**CERTIFICATE OF APPROPRIATENESS**

**Property:** 614 W Main Street, Tracts 6 and 7, Block 8, Lockhart Connor and Barziza Subdivision. The property includes a historic 1,887 square foot, one-story wood frame single-family residence situated on a 5,000 square foot (50' x 100') interior lot.

**Proposal:** Alteration – The applicant was denied a COA at the November 2014 HAHC meeting for the installation of 40” high cementitious foundation skirting panels. The applicant has revised the application and is now requesting approval to install trim board under the existing drip board to the top of the foundation piers and metal lattice skirting between the existing perimeter foundation piers.

**SKIRTING DETAIL**

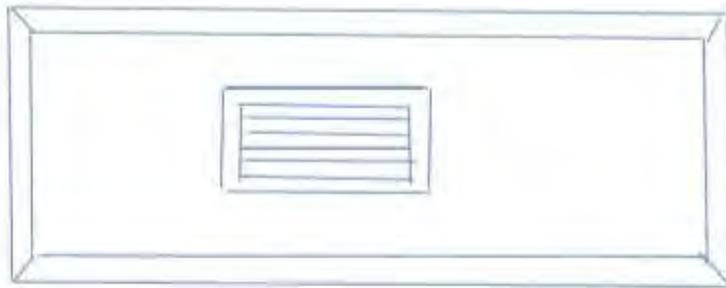
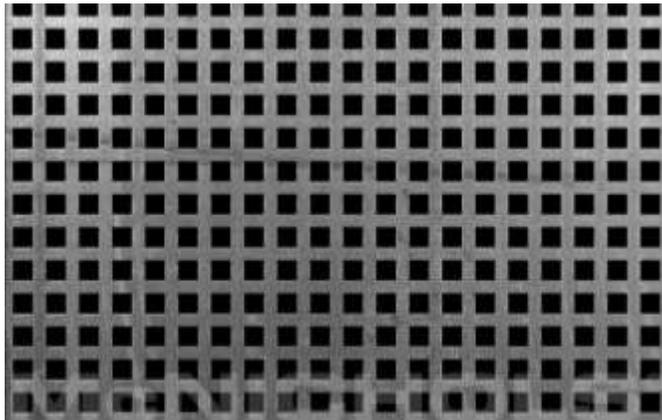
DENIED – 11/20/14

1. Smooth Hardi panel. 6' or 7' width (varies)
2. 40" height
2. 1" x 4" Hardi trim (around edge)
3. 1" x 2" Hardi trim (around vent)
4. Metal vent that can be closed or opened

\*Not every panel will have a vent. Some panels will be solid.

**Exterior Materials:** A trim board will be installed under the existing drip board to the top of the existing foundation piers, the proposed metal lattice skirting panels will be installed under the trim board between the existing perimeter foundation piers on the north, west, and east elevation.
